UNITED STATES
NUCLEAR REGULATORY COMMISSION
OFFICE OF INSPECTION AND ENFORCEMENT
WASHINGTON, D.C. 20555

February 26, 1982

IE INFORMATION NOTICE NO. 82-01, REV. 1: AUXILIARY FEEDWATER PUMP LOCKOUT
RESULTING FROM WESTINGHOUSE W-2
SWITCH CIRCUIT MODIFICATION

Figure 3

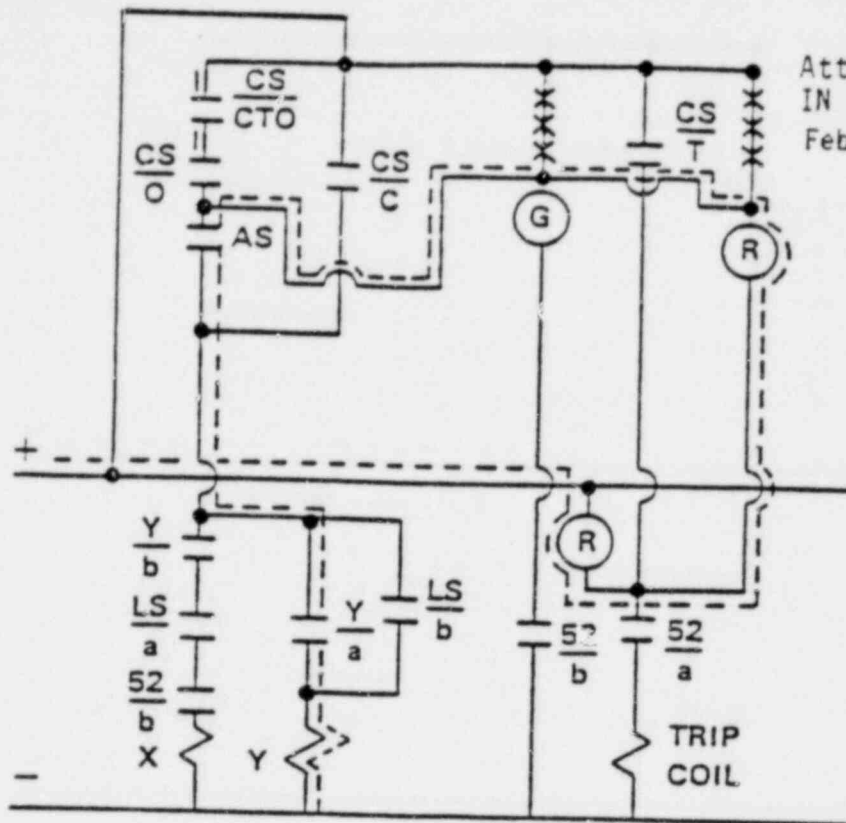
Due to a reproduction problem, Figure 3 of IE Information Notice No. 82-01 was incomplete as issued to some power reactor facilities holding an operating license or construction permit. A reissue of Figure 3 is attached. Table 1 is also revised to further clarify the circuit diagrams.

NOTE: TRIPPING BREAKER WITH AUTO-START SIGNAL PRESENT WILL OPEN CONTACTS $\frac{CS}{CTO}$ AND $\frac{CS}{O}$, AND OPEN CONTACT $\frac{52}{a}$, THE SNEAK PATH WILL PERSIST IN KEEPING (Y) COIL ENERGIZED THEREBY PREVENTING CONTACTS $\frac{Y}{b}$ AND $\frac{Y}{a}$ FROM CHANGING STATUS TO ENERGIZE THE UNLATCHING (X) COIL AND RECLOSE THE BREAKER ON DEMAND.
